To All Lamborghini Dealers and Licensed Service Point  
From Customer Service Department  
Subject Service campaign – Fixing of Gallardo Shock Absorbers Covers  
Group 140.4.11.00.05 (front) and 140.5.12.00.05 (rear)  
Date 18.07.2005  
Pages 7

Fixing of the Gallardo shock absorbers protection covers.

All Gallardo models until VIN ZHWG\_11\_\_5LA02579

Picture 2

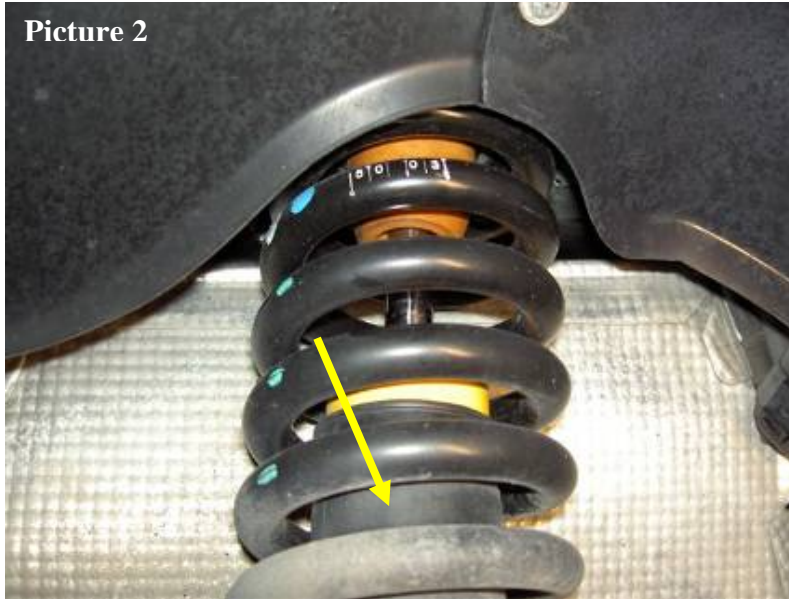
1.4 Identify the black protection cover (pictures 1, 2) and check the protection cover position.

If the cover is in a not correct position (pic.2) go to operation 1.6.

Picture 3

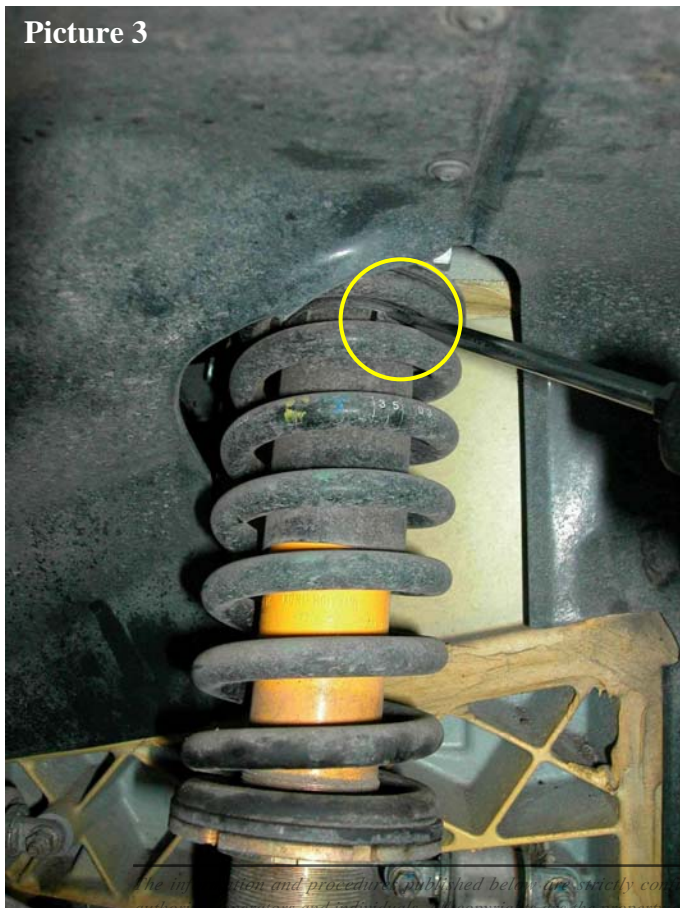
**1.5** If the cover is in the correct position (pic.1), remove it from its upper fixing point, using a screw driver (pic. 3), in order to carry out the rework and go to operation 1.6.

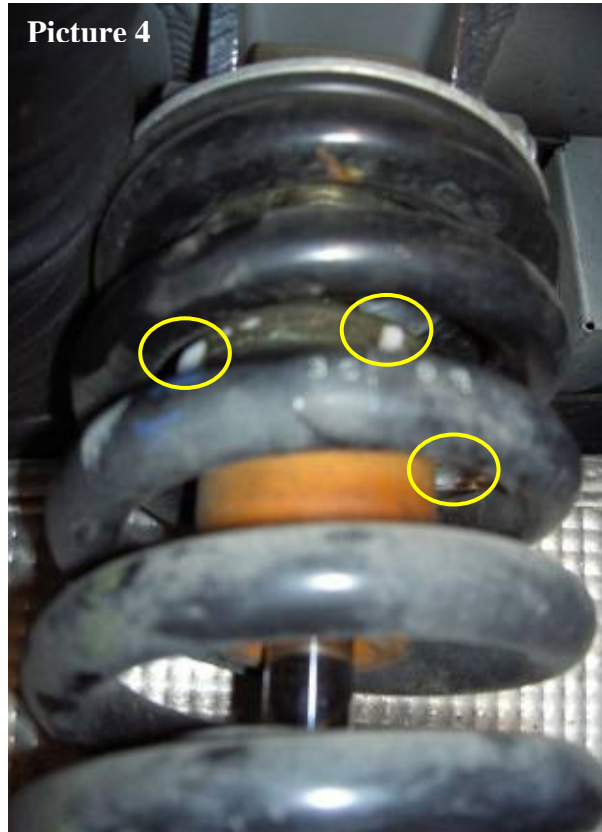
**1.6** Using the glue gun, apply the glue in four points to block the protection (use the gloves when operating the glue). (picture 4)
